**2021 USEPA CCR RULE PERIODIC
OPERATING RECORD RUN-ON AND RUN-
OFF CONTROL PLAN REVIEW REPORT**

§257.81

LANDFILL

**Duck Creek Power Plant
Fulton County, Illinois**

INITIAL TO PERIODIC SURVEY COMPARISON
LANDFILL
DUCK CREEK POWER PLANT
CANTON, ILLINOIS

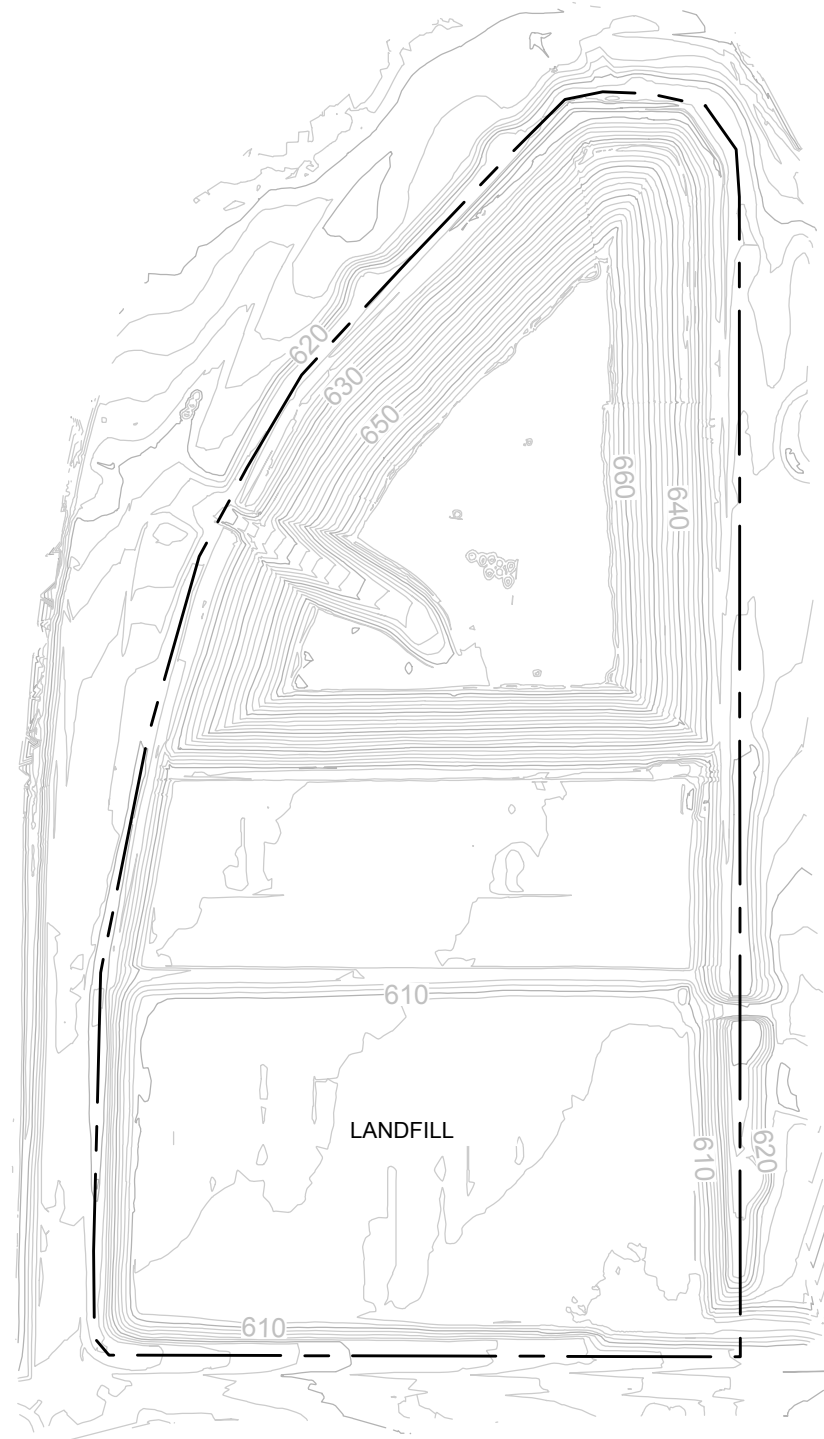
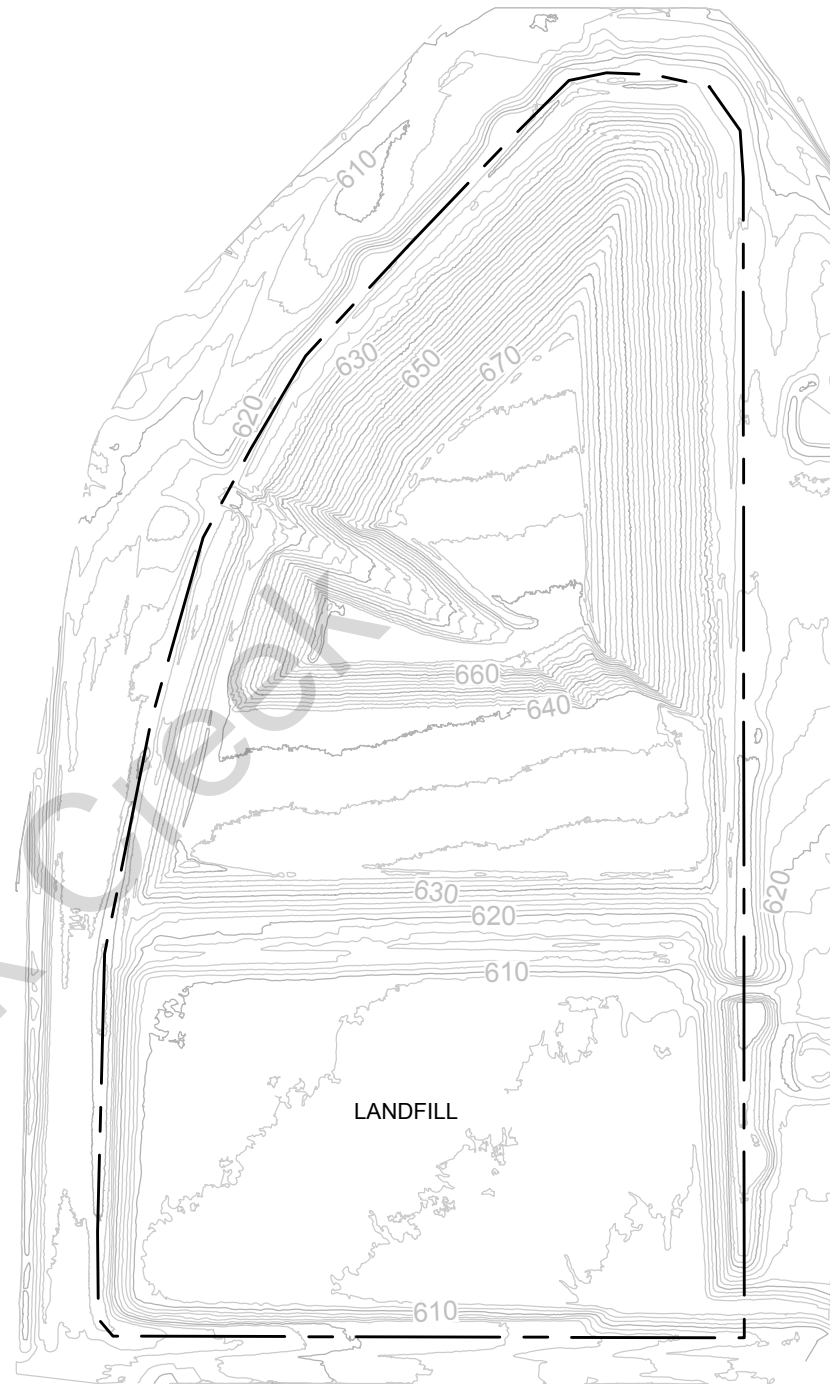
LF used for the existing run-on, run-off control plan ([2], [3]). This comparison is presented in a plan view side-by-side of the surveys in **Drawing 1** and an isopach map denoting changes in ground surface elevation in **Drawing 2**. A summary of the changes in CCR volumes is provided in **Table 1**.

The comparison indicated that approximately 262,000 CY of CCR was placed in the LF between 2015 to 2021. Most of the CCR was placed within Cell 1B, which had not yet received CCR in 2015. Changes in grading and some CCR placement also occurred at the top of Cell 1A. Some minor sedimentation of perimeter ditches was also noted, however periodic sedimentation is being addressed as part of routine maintenance, as indicated in the annual inspections ([4], [5], [6], [7], [8], [9]). The comparison did not indicate that CCR had been placed outside the design grades of the LF.

INITIAL TO PERIODIC AERIAL IMAGERY
COMPARISON
LANDFILL
DUCK CREEK POWER PLANT
CANTON, ILLINOIS

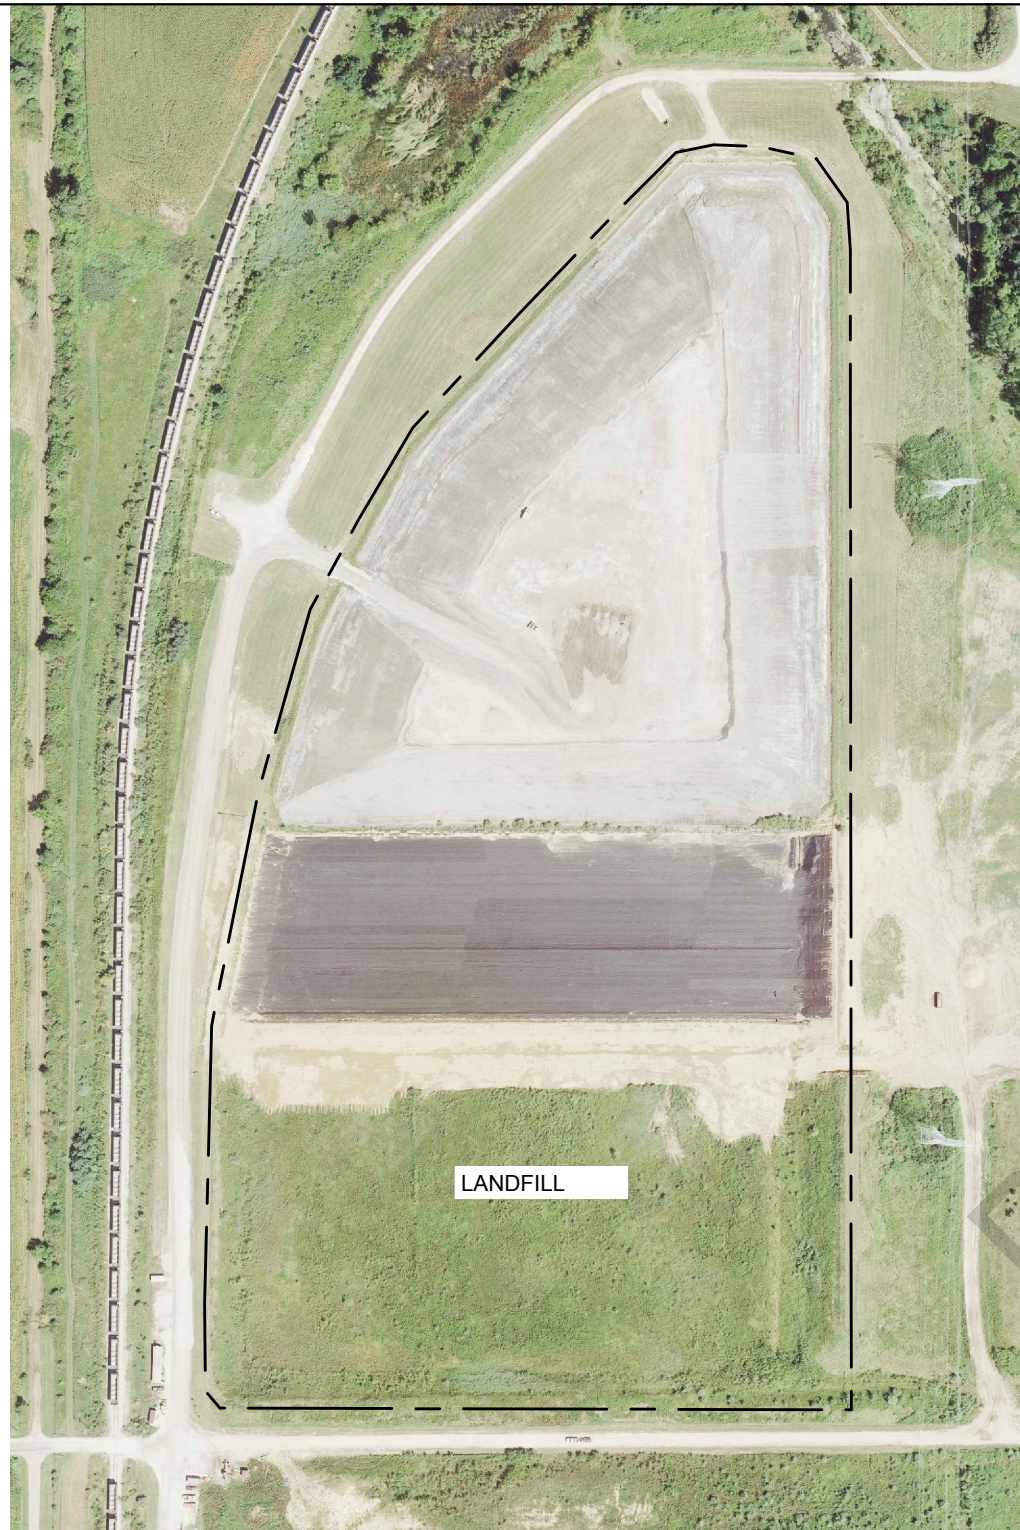
Initial aerial photographs of the LF collected by Weaver Consultants in 2015 [10] were compared to periodic aerial photographs collected by IngenAE, LLC in 2020 [11] to visually evaluate if potential site changes (i.e., construction of new ditches, changes in site operations, or changes to other appurtenances) may have occurred between 2015 and 2020. A comparison of these aerial photographs is provided in **Drawing 3**, and the following change was identified:

- Cell 1B was constructed in 2015 but had not yet received CCR. CCR was placed in Cell 1B starting circa 2016, as indicated by the periodic aerial imagery.
